**PLANNED UNIT DEVELOPMENT,  
REZONING, SUBDIVISION,  
& SIDEWALK WAIVER STAFF REPORT**

**Date: July 20, 2006**

**NAME** Louis J. Naman Subdivision, Resubdivision of Lots 2 & 3

**LOCATION** 4125, 4137, 4151, and 4203 Moffett Road  
(Southwest corner of Moffett Road and Wolf Ridge Road)

# SITE PLAN

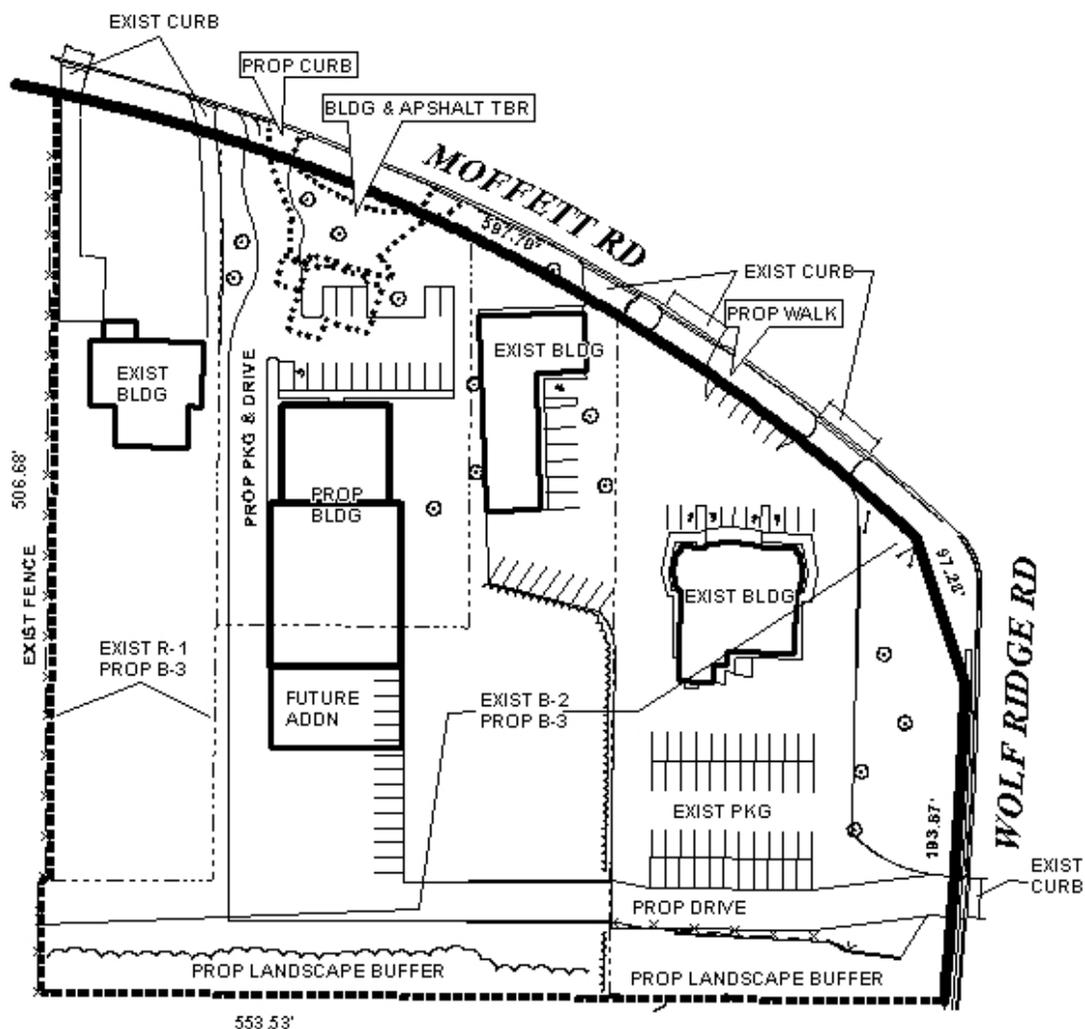
The PUD site plan illustrates shared access between three lots, to allow existing Lot 4 and proposed Lots 1 and 2 shared access to Wolf Ridge Road. The applicant states that the curvature of Moffett Road along the site presents visibility concerns, and that this is a safer alternative outlet for the three sites. Based on this reasoning, the site should be limited to a single curb cut to Moffett Road for each lot (removing the circular drive on proposed Lot 1, as shown on the site plan); and future redevelopment of existing Lots 1 and 4 of the original Louis J. Naman Subdivision (the church and restaurant sites) should be limited to a single curb cut to Moffett Road; with size, location, and design of all curb cuts subject to Traffic Engineering approval.

The site plan shows a future addition at the rear of the proposed warehouse building on proposed Lot 1, which would supplant six parking spaces. To prevent a future parking deficit, an Administrative PUD application would be required at the time of the addition.

It should be noted that parking shown on the plan for the restaurant site (Lot 4) does not mirror that shown in aerial photos of the site; and no striped parking is shown for the church site (existing Lot 1). In addition, landscaping and buffering may not currently meet the requirements of the Zoning Ordinance. Full compliance with all municipal codes and ordinances, including landscaping, buffering, and parking, should be a condition of PUD approval, to be satisfied as soon as practicable. Landscape buffers should be provided as shown on the plat submitted.

**Planned Unit Development:** Based upon the preceding, this request is recommended for Approval, subject to the following conditions: 1) compliance with Engineering comments (*No drainage patterns were shown as required by the Subdivision Regulations, therefore, a thorough evaluation of drainage concerns could not be completed. A Hold Harmless agreement will be required if stormwater runoff is increased and/or concentrated onto an adjacent property. All increase in impervious area since the implementation of the COM Stormwater Ordinance must be accounted for and be brought into detention compliance. Must comply with all stormwater and flood control ordinances. Any work performed in the right of way will require a right of way permit. The applicant is responsible for verifying if the site contains wetlands. If the site is included on the NWI, it is the applicant's responsibility to confirm or deny the existence of regulatory wetlands.*); 2) compliance with Urban Forestry comments (*Property to be developed in compliance with state and*
